# City of Stockton – Public Works Department

## Questions & Answers

**Project:** New City Hall Renovations and Relocation

### Questions & Answers No. 4 – February 17, 2022

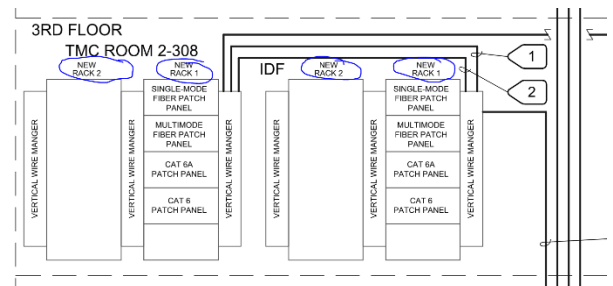
Q6: Have the existing sealants been tested for contaminants (i.e. lead, asbestos, PCB's, etc.)?

A6: See Appendix D, Environmental Regulated Materials Survey Report which indicates findings and materials tested. Sealants observed and not found to be suspect were not included. The buildings were built in 1983 and PCB's were not used in construction materials since it was included in the pollutant listing by the EPA in 1973 and banned from usage in 1978, buildings should not have PCB's. Bid the job per findings indicated in Appendix D.

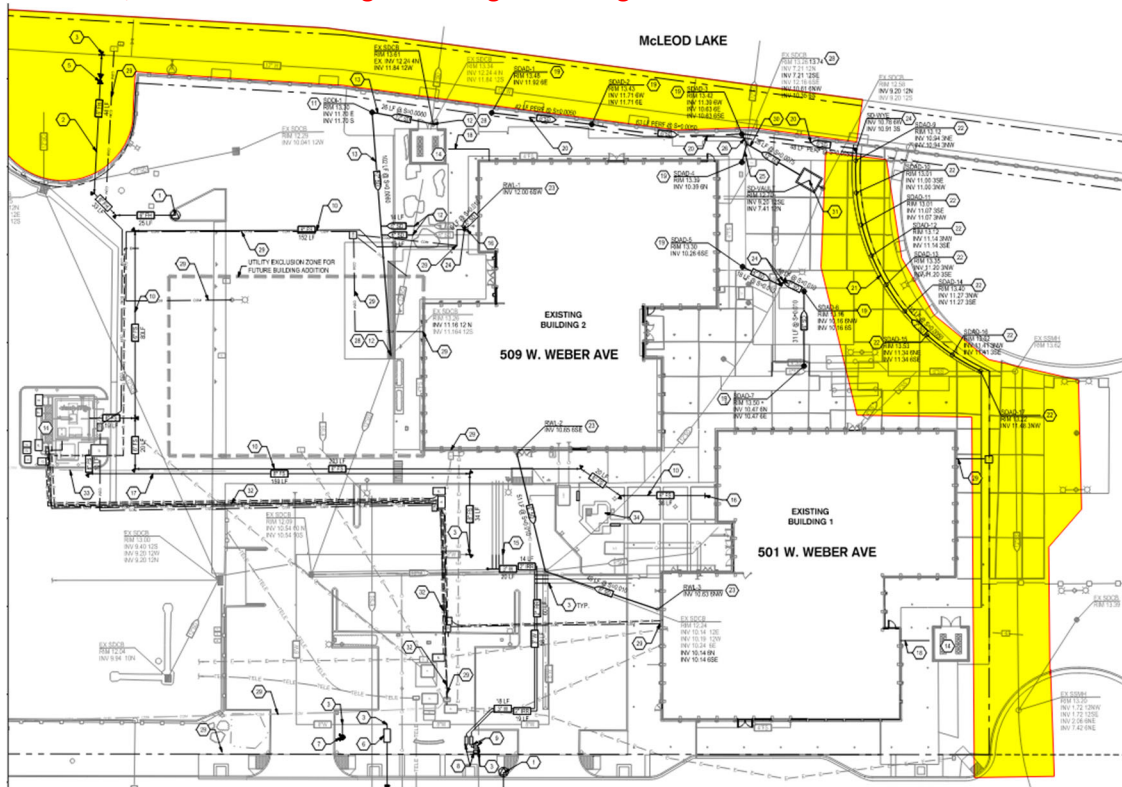
Q22: High density storage: What systems are new vs which ones are being moved? Are the existing systems electric or mechanical? Are the new Systems electric or mechanical and please identify on the drawings where the new one's are located. Which Manufacturer was used (ie: Spacesaver, Aurora, Montel, etc.) for the currently installed systems?

A22: Reference plans which denotes new vs. existing systems. Demo plans indicate existing systems that will be removed and returned to City. Existing hi-density storage on 1<sup>st</sup> floor building 1 is motorized, and the one in 5<sup>th</sup> floor building 2 is mechanical. New system is located on second floor of building 1, see floor plan and detail for more information and spec 10 56 26 for new system.

Existing motorized hi-density storage to be removed at first floor – Building 1: Manufacturer: Kardex

Existing mechanical hi-density storage to be removed on fifth floor – Building 2: Manufacturer: Aisle-Saver by White
